Proposed modifications in Scheduled traffic state machines

802.1Q-Rev D1.4 p.139 *Note: The blue letters are the proposed modifications (additions) to support frame preemption*

Proposed modifications in List Execute state machine

Figure 8-15—List Execute state machine

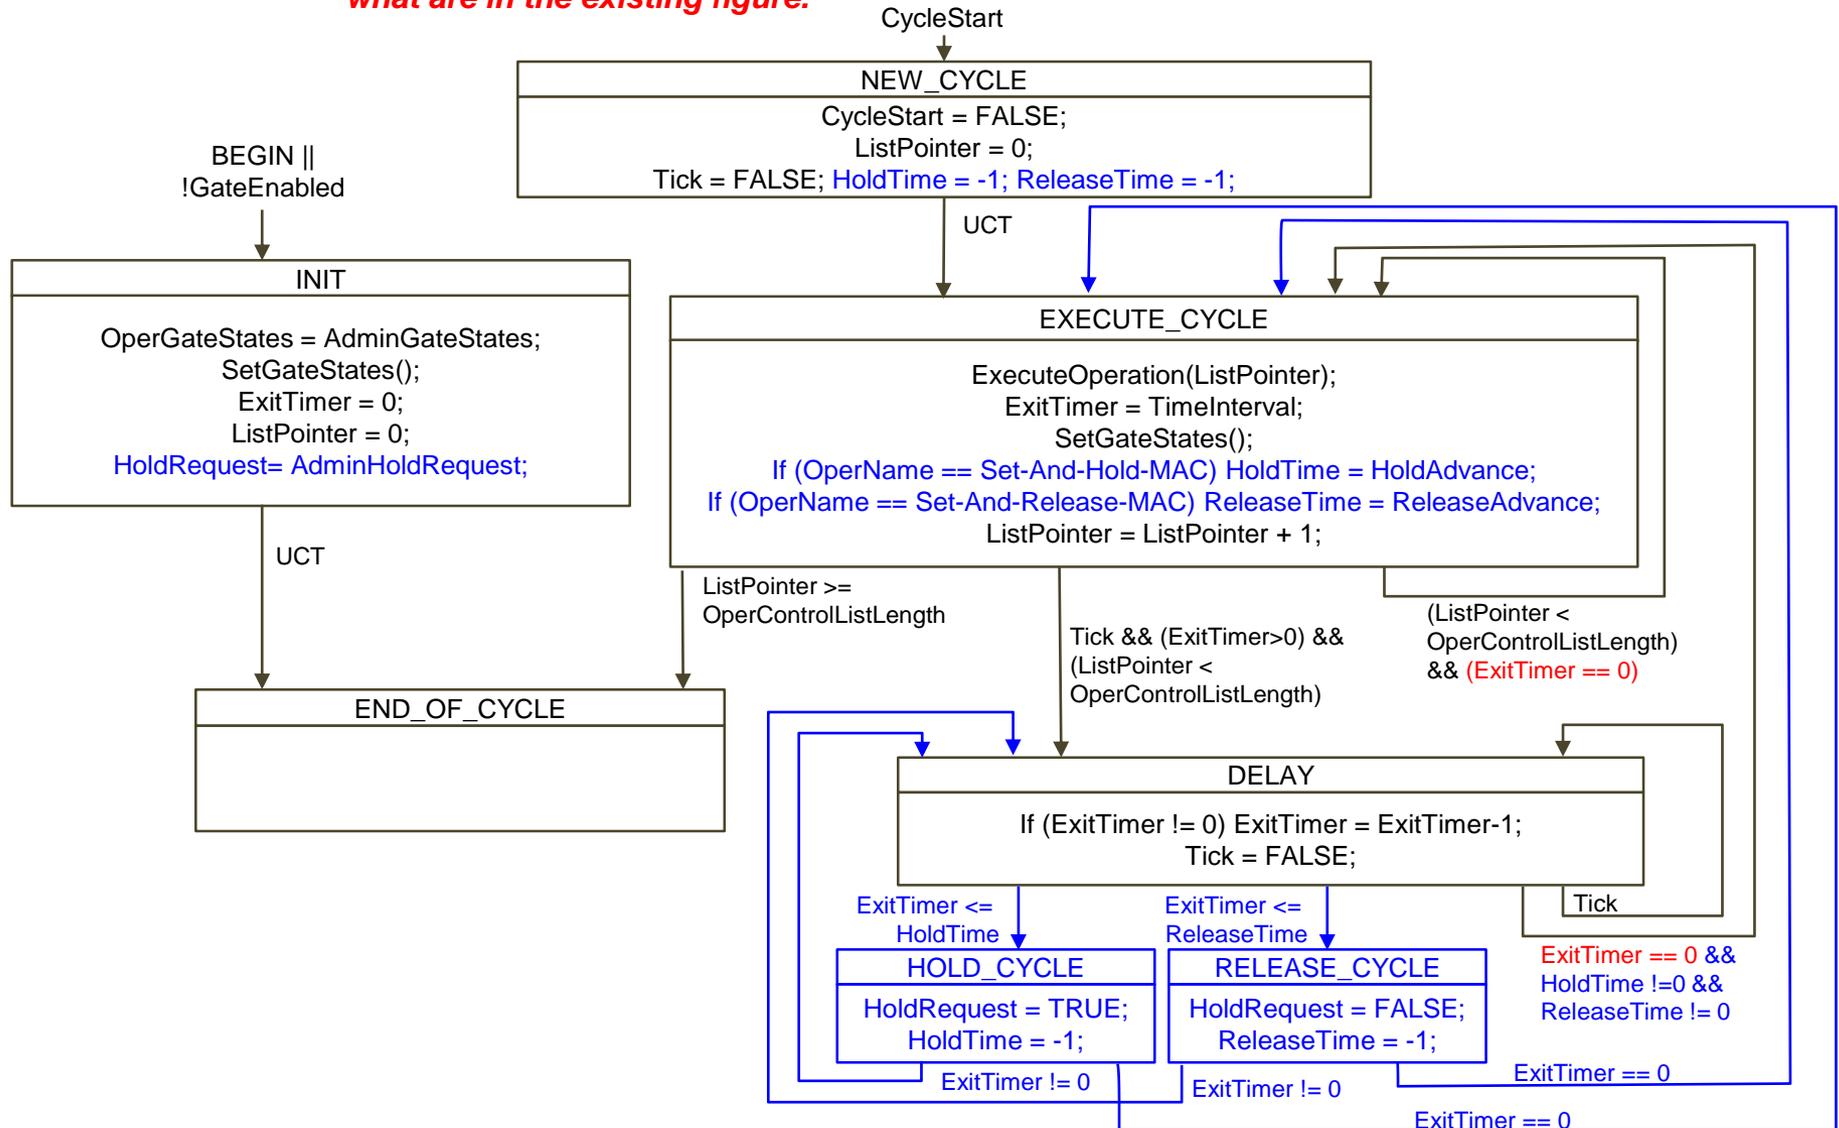
802.1Q-Rev D1.4 p.141 *Note: The blue letters are the proposed additions to the existing figure. The red ones replaces what are in the existing figure.*
